From: Anna Kramarczyk <Anna.Kramarczyk@midsussex.gov.uk>
Sent: 17 December 2025 17:14:43 UTC+00:00
To: "Joseph Swift" <Joseph.Swift@midsussex.gov.uk>
Subject: RE: DM/25/2187 - Land To The West Of Freeks Lane (Phase 3)

From: Joseph Swift <joseph.swift@midsussex.gov.uk>
Sent: 12 December 2025 11:55
To: Anna Kramarczyk <Anna.Kramarczyk@midsussex.gov.uk>
Subject: FW: DM/25/2187 - Land To The West Of Freeks Lane (Phase 3)

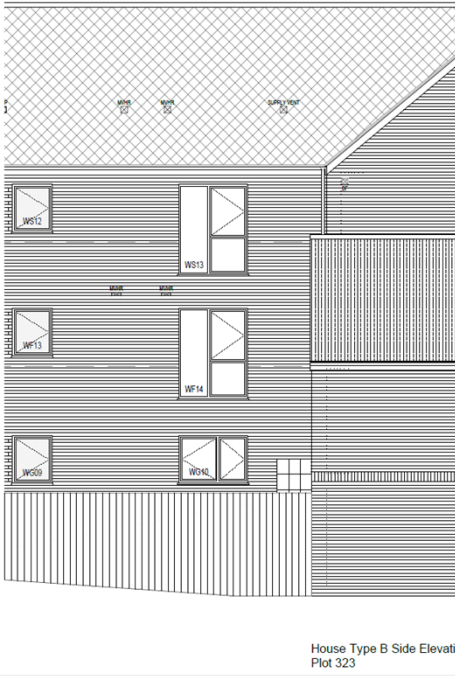
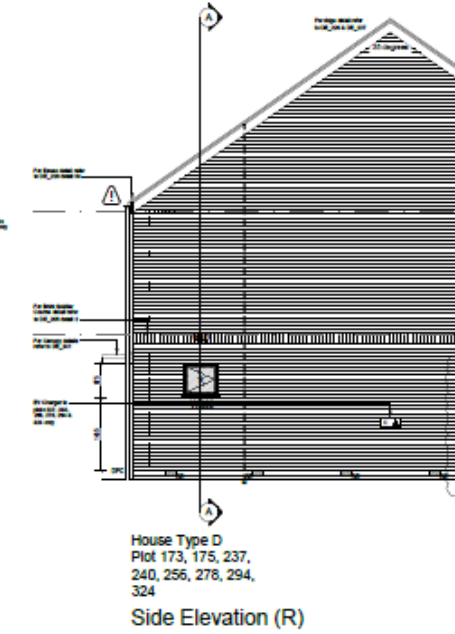
Condition 1 in part states: ‘Re-designed corner flanks incorporating additional fenestration on plots 15, 19, 20, 24, 25, 26, 29, 38, 173, 441 and block 12's west flank and block 14's east flank.’ As per the following plans in relation to block 12, it does not appear that any additional fenestration has been added to the western flank elevation.		The elevation is screened by Plot 323 and lies approximately 1.1 m from the site boundary, as illustrated in new streetscene elevation (Elev A) and side elevation (Elev B) plan reference S0035_HB3_PL110 (attached). Additional fenestration in this location is therefore not proposed, and this has been accepted in relation to apartment block 6.	The 4-metre distance and change in levels will make it a highly visible flank elevation and as per the condition, additional fenestration is required.
This is the same for Plot 173, no additional openings have been provided to the flank elevations.		Additional living room side window now shown as per new plan ref. S0035_HB3_ELEV_0314.	We would also expect a window added to the first floor (possibly serving the staircase) as this is also a highly visible elevation and serves an important function of passive surveillance over green open area.

In addition, we don't appear to have details of the cladding (colour) adjacent to the door and the reference does not match the submitted plans (DE 215).		Noted on Material Schedule – see attached.	Noted, acceptable
Furthermore, is it proposed for the glass to be obscure glazed? We would prefer this to be clear glazed.		Obscure glazing is proposed only for the front door, WC, bathroom & en-suite, as shown by the hatched markings on the elevations.	Noted.
Finally in the relation to the gas boxes, please can you provide us with an image of how this would look, is there a reason they are located to the front? Can they not be more discreetly located?		Gas meter located to be adjacent to internal boiler and to avoid driveway locations. See photograph attached; please also note that this is freshly planted vegetation (a week or so old), once established the gas metre will be fully hidden.	Noted.

As per the attached, the applicant has come back and made changes to the flank elevation of block 12 and also added a window to the stairs on the first floor.

Apologies for keeping you waiting.
Yes, this is all acceptable.
